DEVELOPMENT APPLICATION

PROJECT:
1-13 PARRAMATTA ROAD, ANNANDALE

VOLUNTARY PLANNING
AGREEMENT (VPA) PLAN

VPA ELEVATION AND SECTIONS

EAST ELEVATION
SCALE 1:100 @ A1

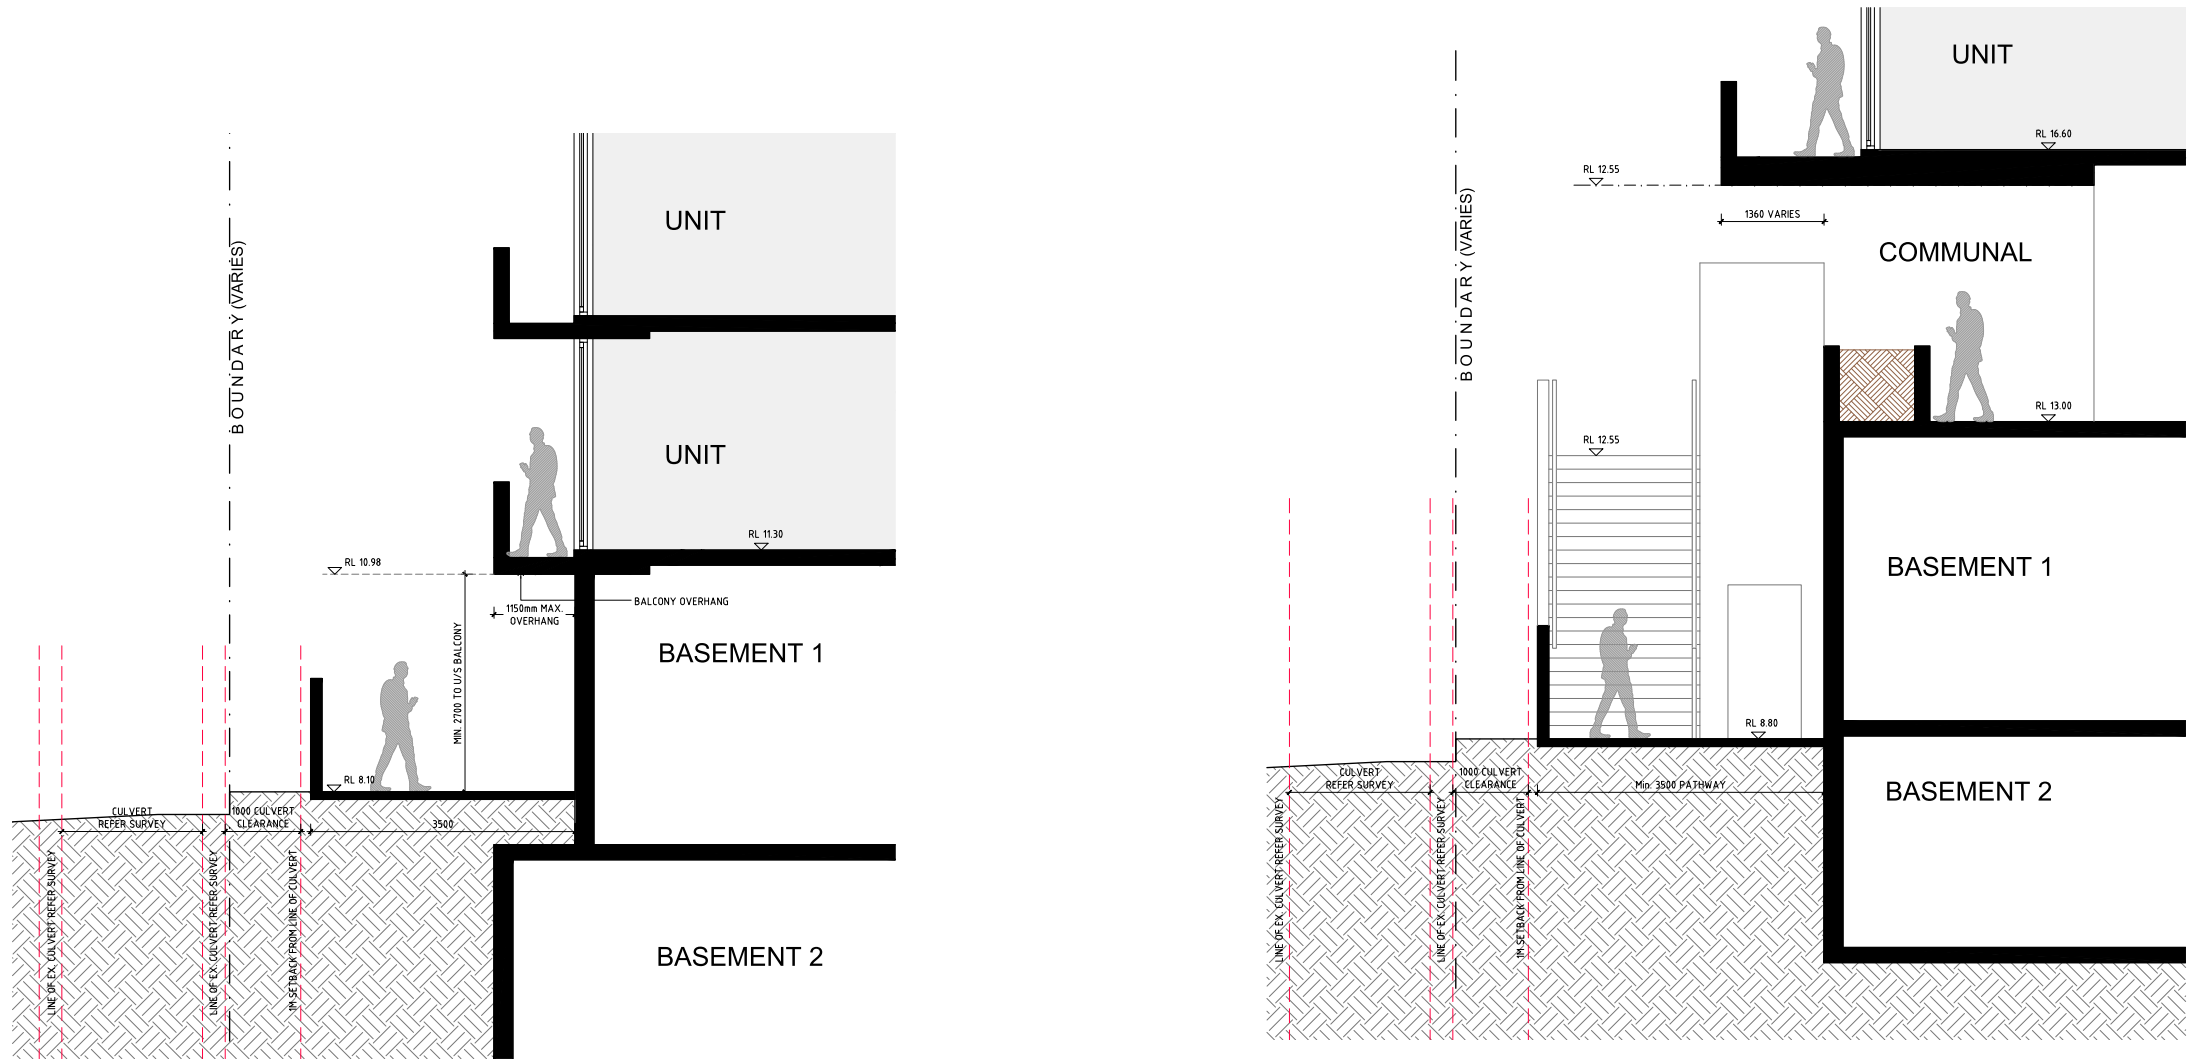
- Relocate services room includes residential & commercial bin rooms, waste holding room, bulky waste room and retail store room
- Rearrange basement general storage and bicycle storage cages

- Relocate parking spaces
- Amend boundary wall to suit Sydney Water sewer diversion and stormwater culvert setback requirements
- Update internal driveway ramp to suit Amendment Item 4 & Item 7

- Update external works on ground floor to suit Amendment Item 4
- Propose ground floor retail amalgamation, reduce basement level 1A & 2A directly below retail

- Update ground floor circulation to suit Amendment Item 7
- Update internal unit layout and glazing location
- Consolidate building services and spatial requirements

- Increase Northern building level 4 floor levels and roof above to provide minimum ADG head height requirement on level 3
- Update communal open space layout

- Propose roof plants and solar panels
- Update parapet height and balustrade added to comply with BCA

4 6
